**THE CITY OF GRETNA
HISTORIC DISTRICT COMMISSION
MEETING**

April 29, 2024 - 4:00 PM

AGENDA

Title Sheet

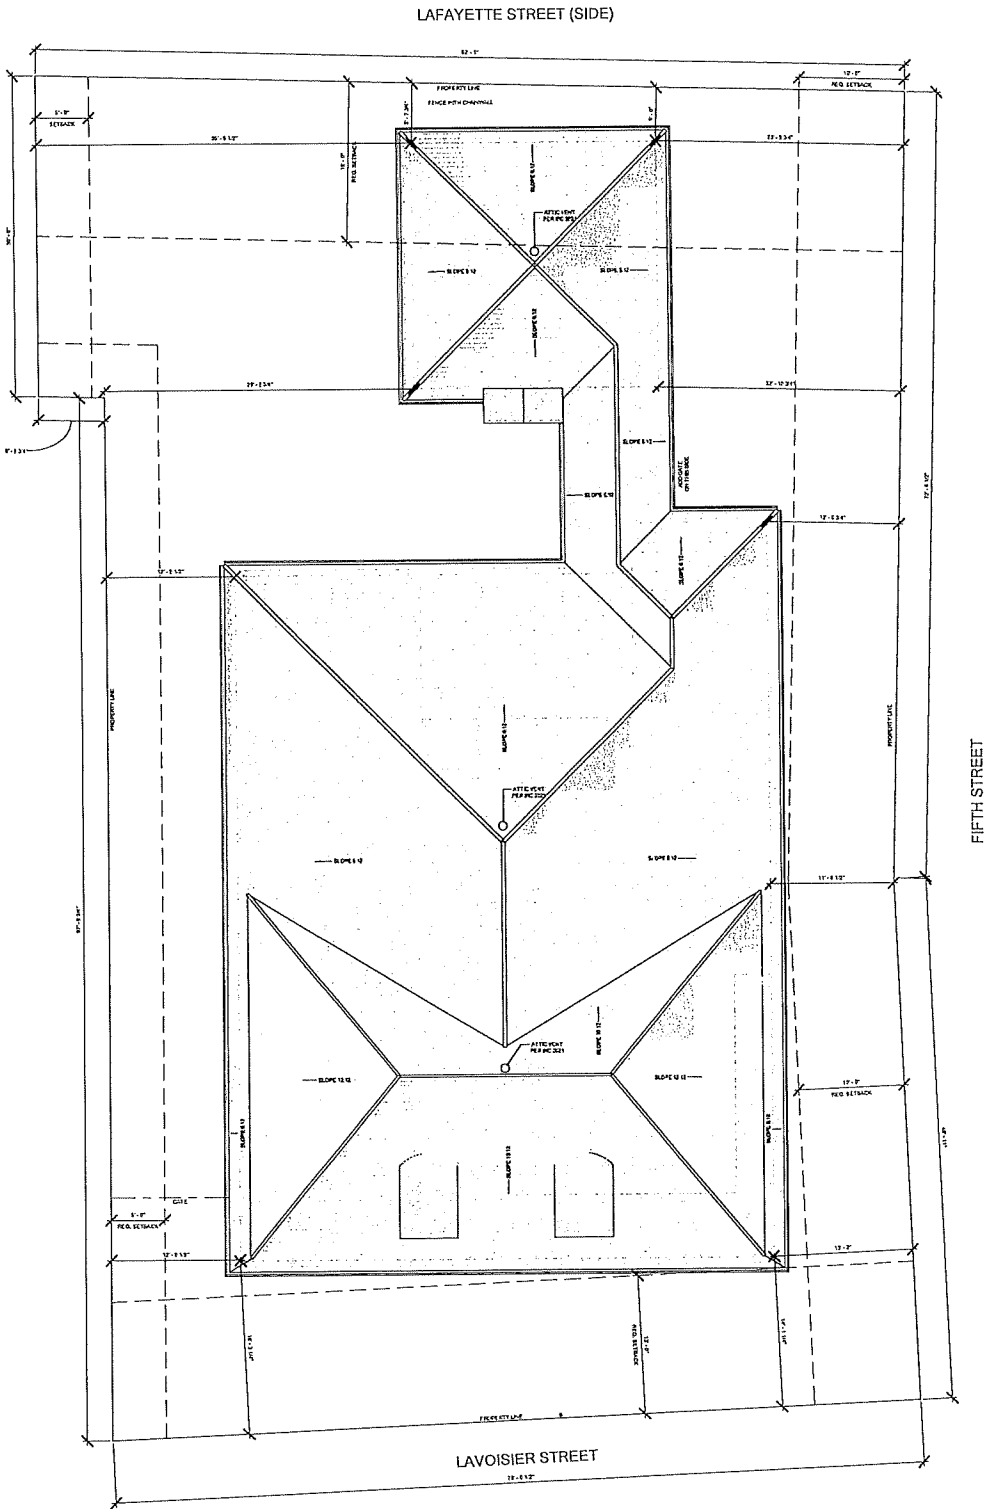
1. Site plan does not include hardscaping - walkway or driveway. Please revise and include that information.
2. Rear setback minimum is 15 feet - garage cannot be attached in current location (under one roof). Either needs to be repositioned or detached to remain.

5. If adding any hardscaping in front yard, must provide calculations showing 50% or more is greenspace.
6. Front setback is showing as 13 feet - please provide statement on plans or in letter that this is the average setback of the homes on the blockface. Rule is 20 foot minimum OR equivalent to the blockface average

7. Site plan requires statement "Post development runoff will not adversely impact neighborhood properties or right of way"
